## **BID NO. SFHS-CAM**

### **SANTA FE HIGH SCHOOL**

### **VIDEO CAMERAS INSTALLATION**

#### **ADDENDUM # 1** **February 21, 2014**

# Santa Fe High School

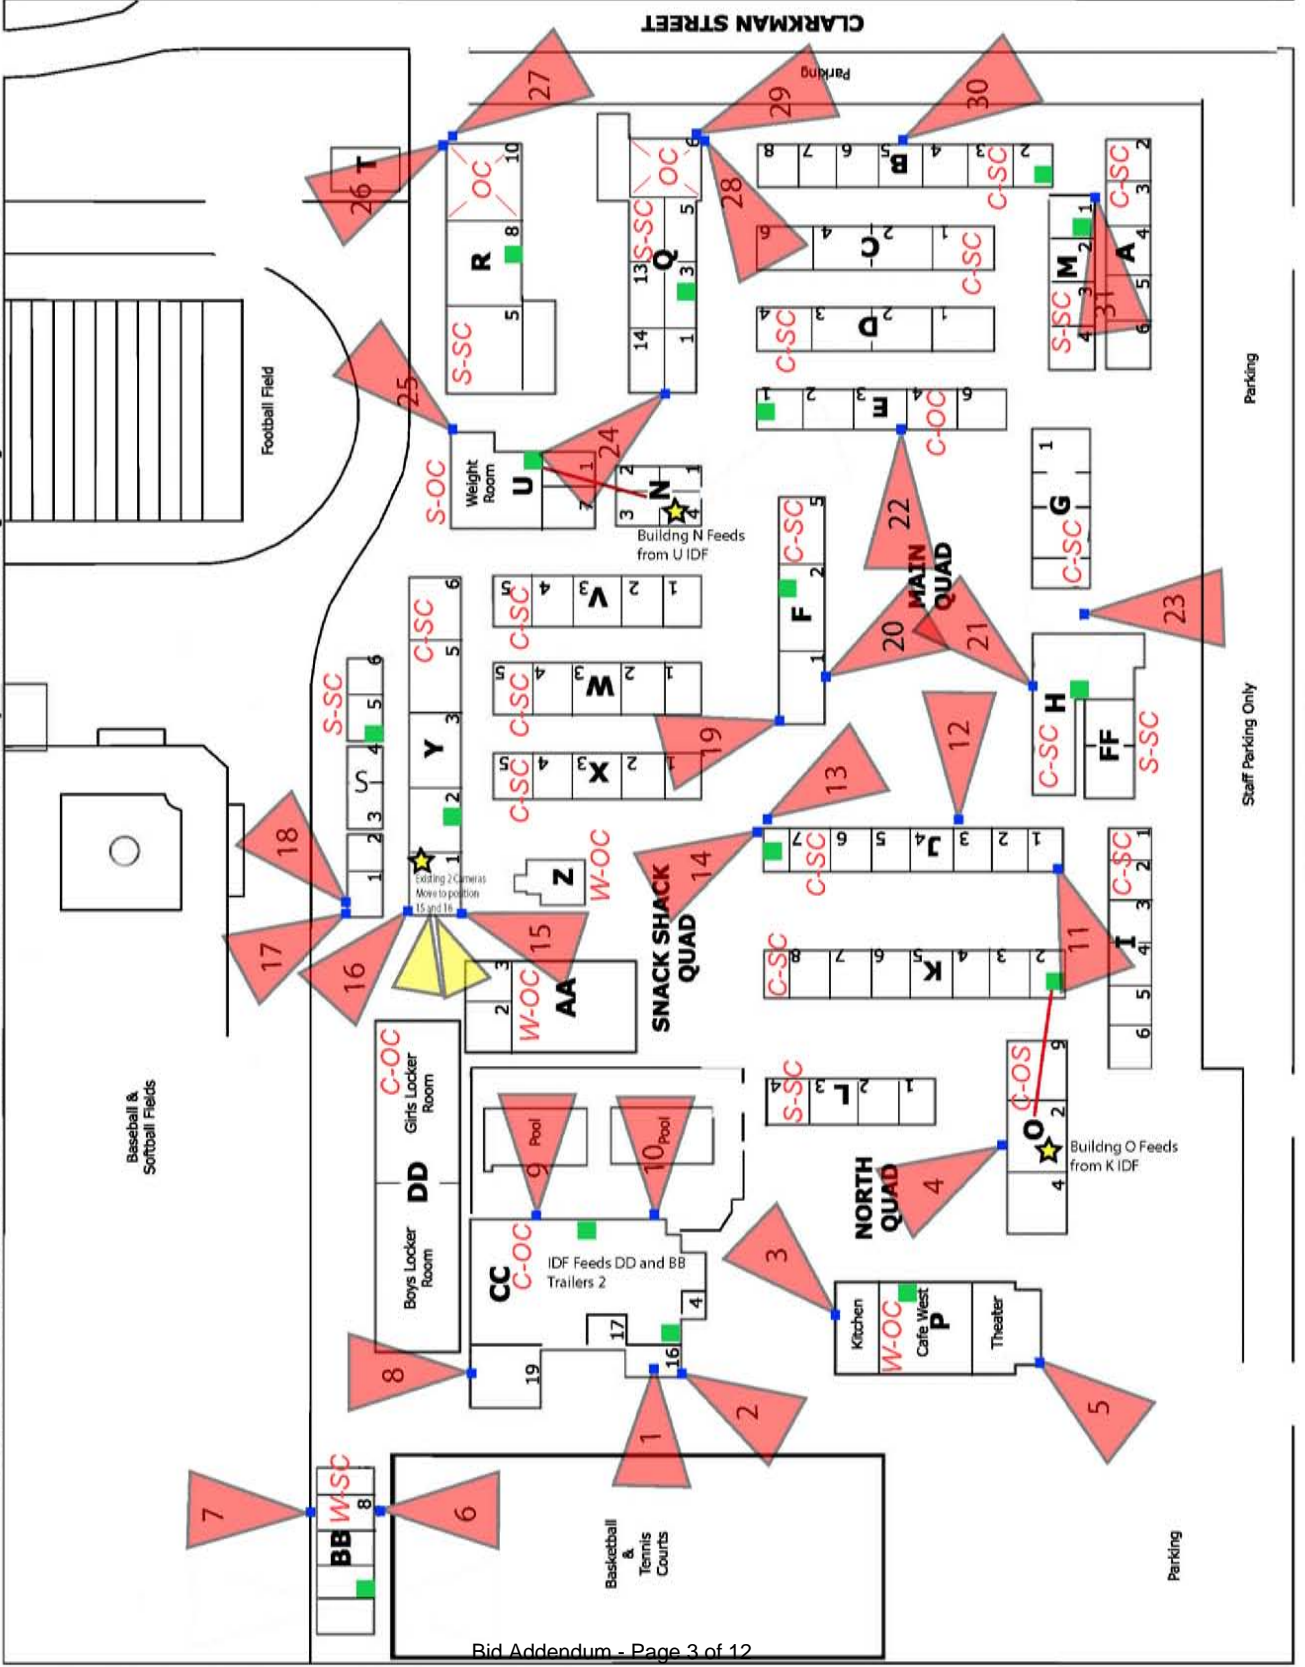
1. Refer to Revised Campus Map (RFP page 281). Camera removed from building 'N'. Also, Bldg. 'N' is not on the Camera Types & Locations (RFP page 282).

6. Camera #1 can be at the same height as camera #2.
7. Camera #6 and #7 should be near building BB room 8. See Revised Campus Map.
8. Camera #13 and #14 should be up on the roof.

10. Room R8, Q6, building 'O', building 'F', and building 'E' do not have T-bar tile ceilings. See revised Campus Map showing Roof & Ceiling Types.
11. Refer to RFP page 277 B3, page 279 Part 2, 2.01 B, and page 280 General Notes 7. The total number of OnSSI camera licenses is twenty one (21), not 19. The Contractor does not need to purchase the camera software license support, only the licenses are needed.

1. See revised campus map indicating the roof and ceiling construction on each building.
2. See revised campus map for relocated cameras on Bldg. 'BB'
3. See revised Campus Map for additional camera on front entry gate area.
4. See revised Camera Types & Locations: Item 4 & 5 (Camera #1 & #2) are to be 'Bullet' camera type.
